# TECHNICAL INFORMATION

No: 76/02/00/NAS  
Ref:  
Issue: 1  
Date: 04/07/00

## Tightening Support Strut Fasteners

Discovery Series II (LT)

Figure 1

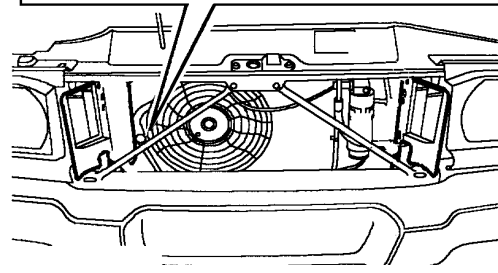
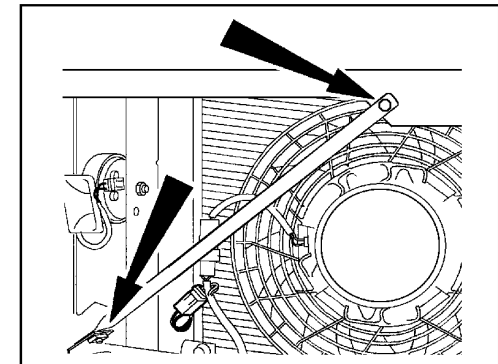
**NOTE: The Figure 1 illustration arrows the upper and lower fastener locations for the right side.**

2. Carefully hold grille forward just enough to gain access to both lower support strut fixing bolts.
3. Torque support strut fasteners on both sides as follows:
  - Using a suitably long extension and 10mm socket, apply a torque of **9Nm (80 lbf.in.)** to both lower support strut bolts.
  - Remove the extension and torque the upper strut bolts to **9Nm (80 lbf.in.)**.
4. Reposition grille and tighten the 3 grille quick screws.
